## Product Change Notice (PCN)

**Subject:** Addition of Final Test Site for Gate Driver IC RAJ2930X0AGM

Label: RAJ2930004AGM

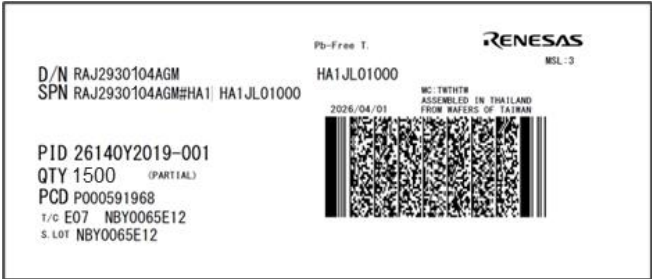
Current FT Site: TPW

Additional FT Site: PZZ
